Xcel Energy Site Permit Amendment Application – Part 1 of 4

August 20, 2019

MPUC Docket IP-6946/WS-17-410

RE: SITE PERMIT AMENDMENT APPLICATION
FREEBORN WIND PROJECT
DOCKET NO. IP-6946/WS-17-410

Attachment B
Turbine Layout Comparison

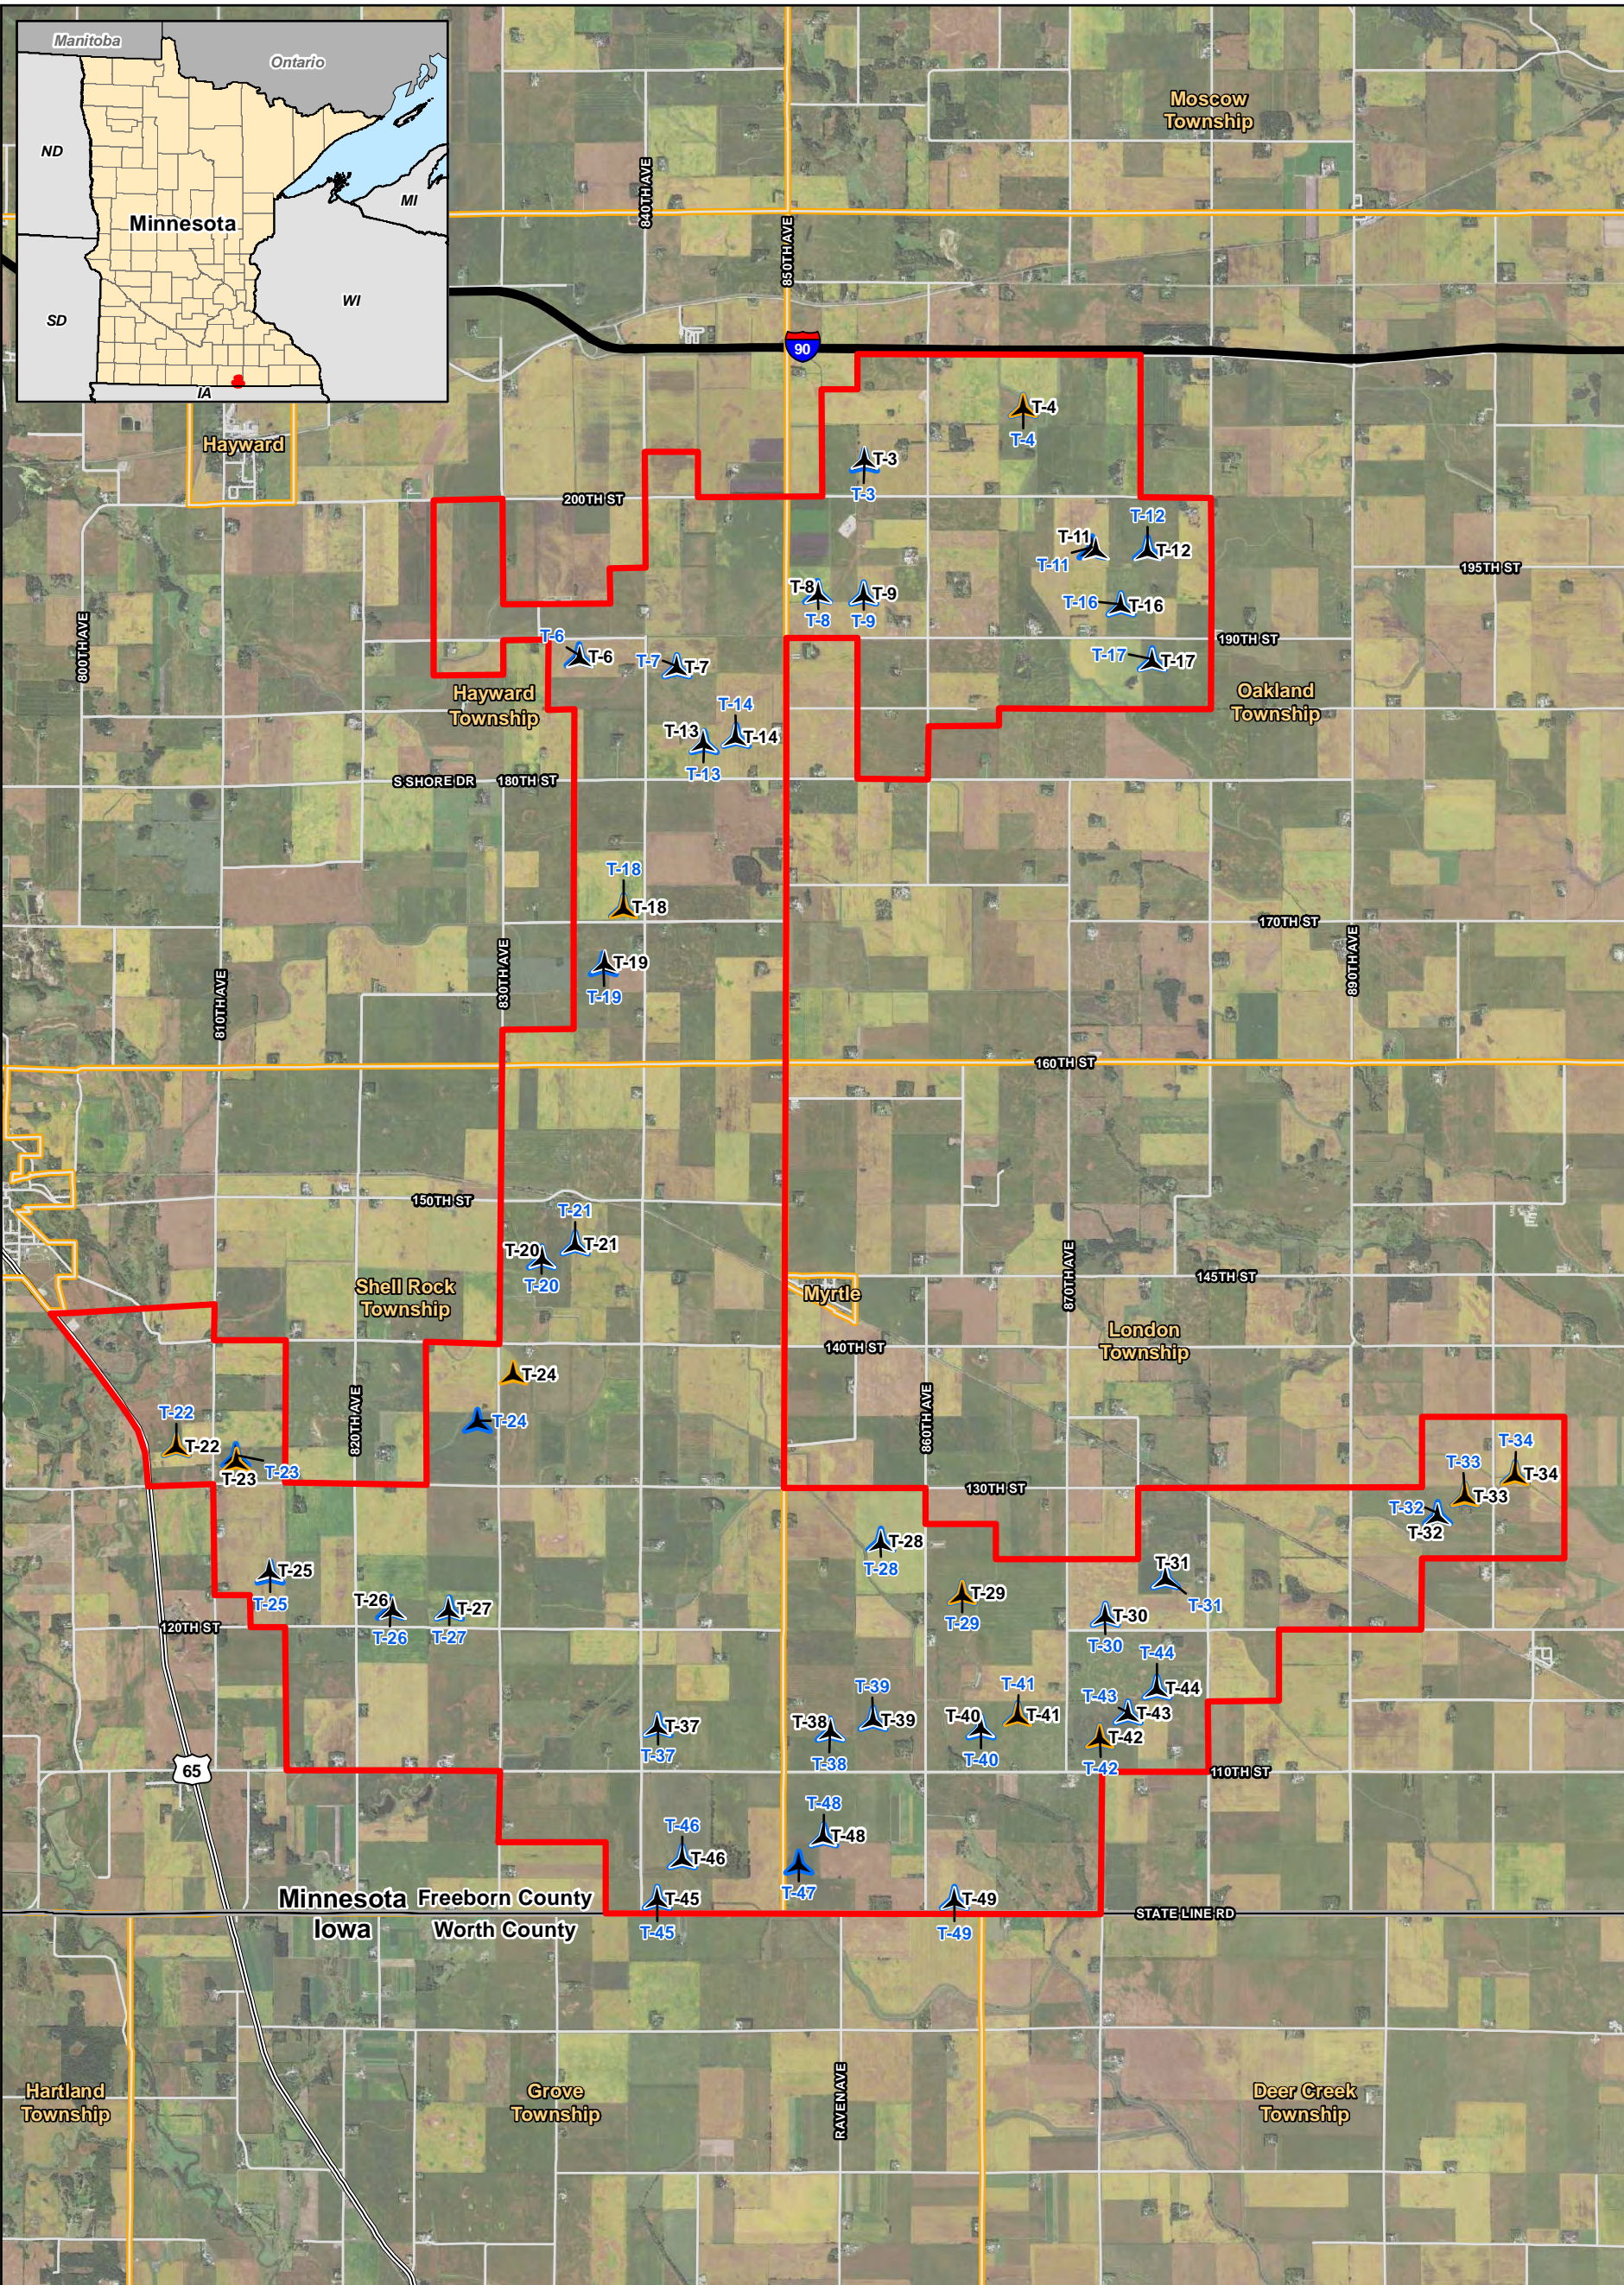
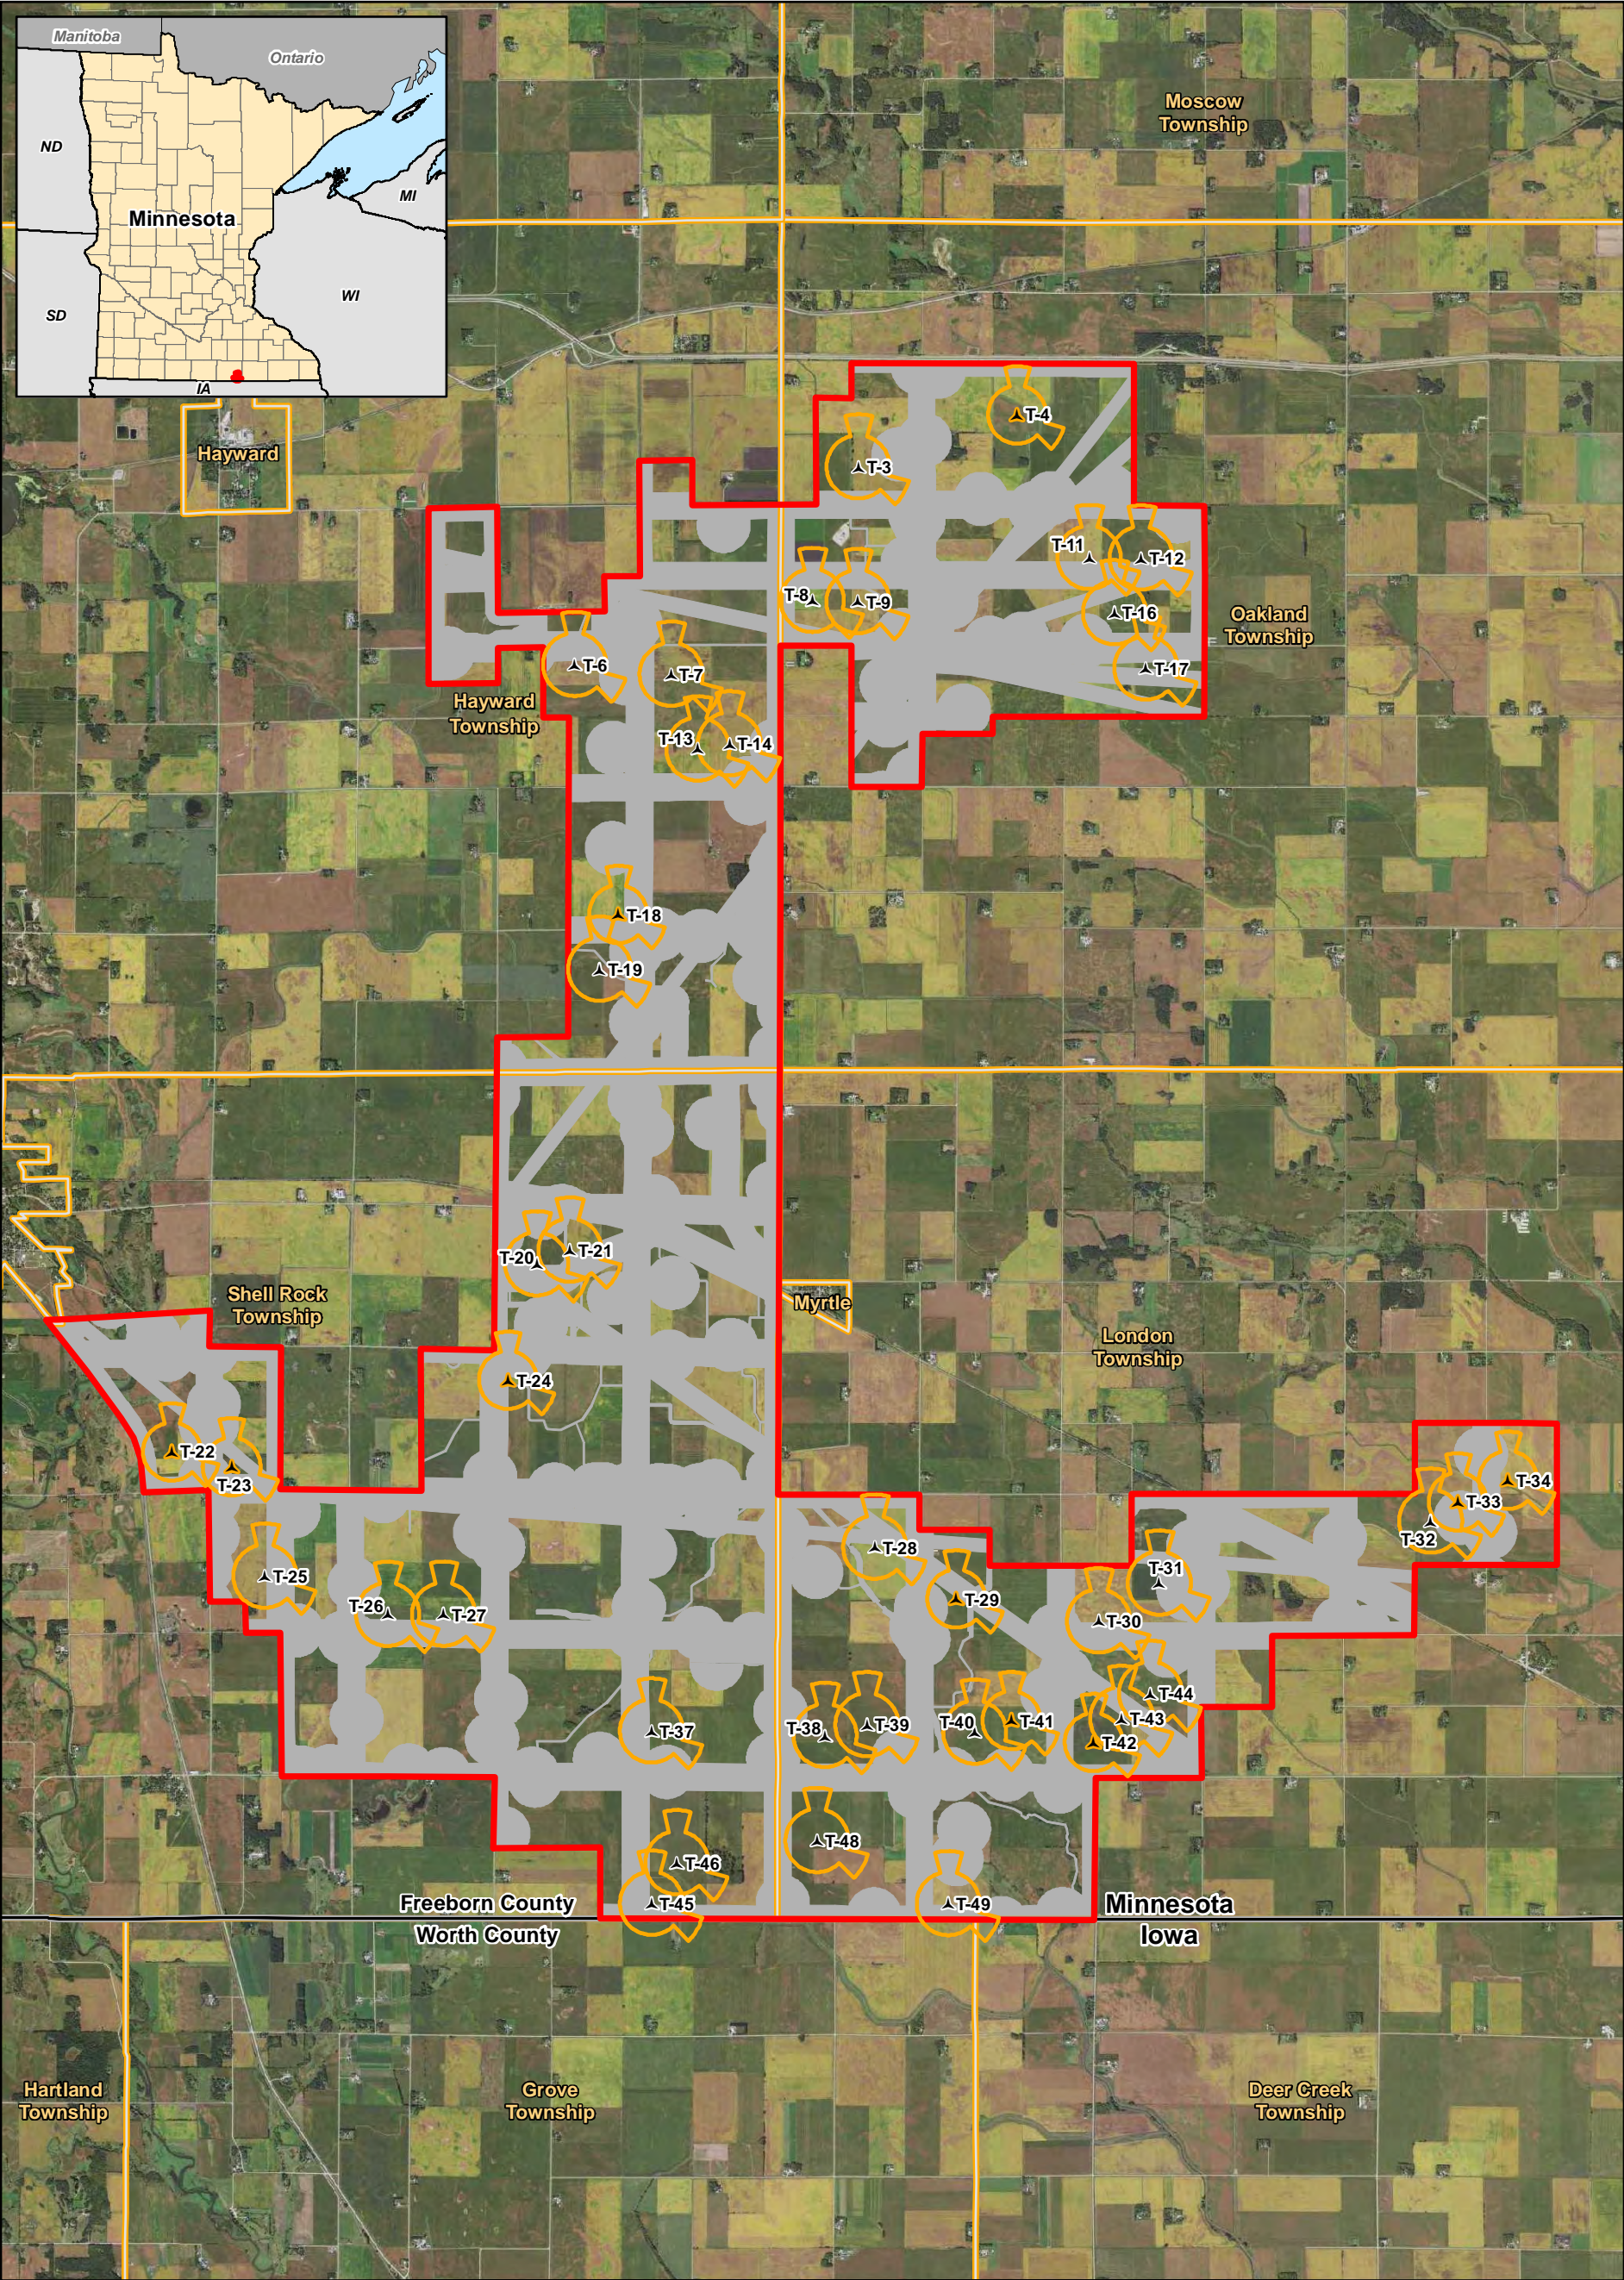
We provide as Attachment B, a figure illustrating the difference between the previously permitted V110/V116 turbine locations and numbering and the current Vestas V110/V120 layout. We additionally provide as Attachment G, a table summarizing the changes in turbine locations. Signage will be present at each turbine location indicating the turbine number and facility ownership.
